Product Change Notice

MK-012354-SL

Issue Date : 26 November 2018

This PCN covers changes to the led polarization as seen in figures 2 below. The end user should connect the long leg which is in the same side of the bung (please see figure 3) to the positive of the power.

Figure 2: new led specification

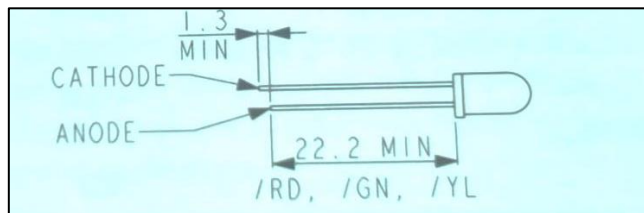
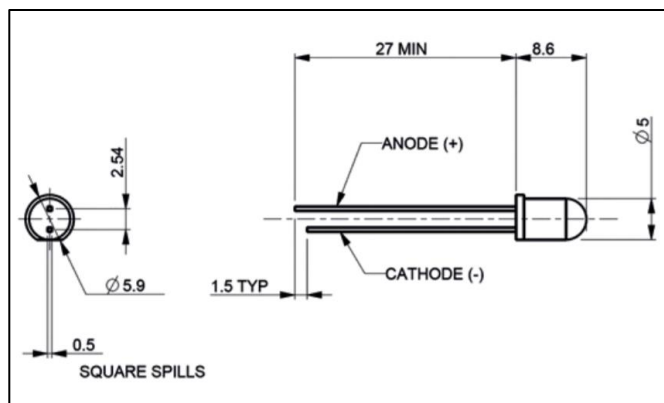
Figure 1 below shows the old led polarization. In this version the long leg is the negative (cathode) and the short one is the positive (anode).

Figure 2 below shows the new led polarization. In the new version the long leg is the positive (anode) and the short one is the negative (cathode). It's almost the opposite of the old version for the Red, green and yellow led color.

Figure 3: polarization Led shown on finished product

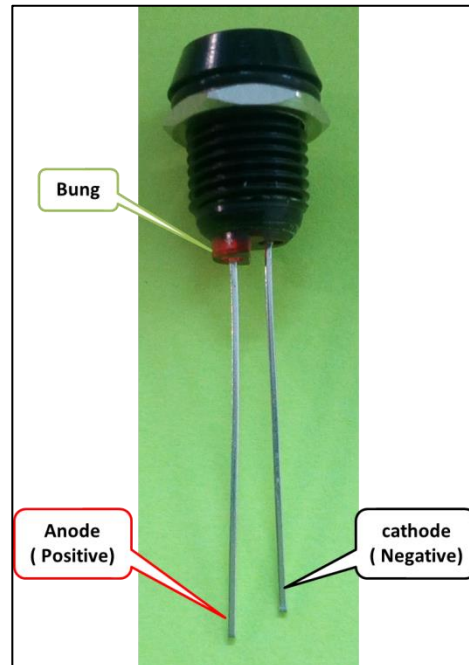
Figure 3 below shows the led polarization on finished product.
